**TECHNCIAL NOTE no.: 22**

Product:	Gearbox Shifting pneumatic system
Part number:	5FR798001
To:	CUPRA Leon Competicion & Audi RS3 LMS
Date:	21/10/2021

1) Air Temperature sensor in location

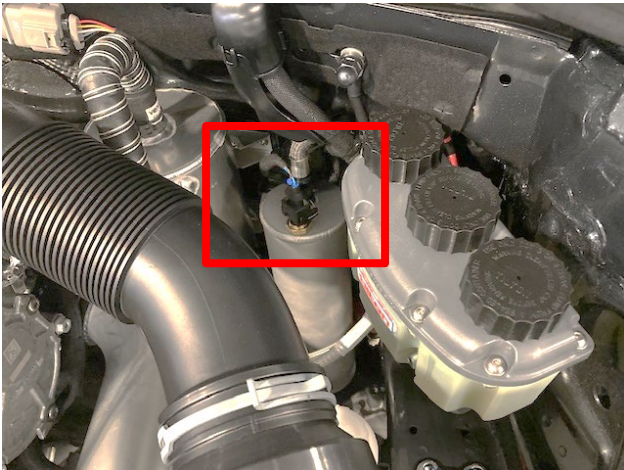
During the 2021 season, there have been some reports regarding a fault in the shifting compressor air temperature sensor, noting air leaks through the sensor in some units.

You will be able to detect it:

- a) Because you will see that the silicon seal of the cable has been lifted.
- b) Because the compressor starts very often (check no leakages in the line)

In the future, that sensor will be an optional part and a cap will be installed in replacement of the sensor. The connector on the wiring loom will remain in the car.
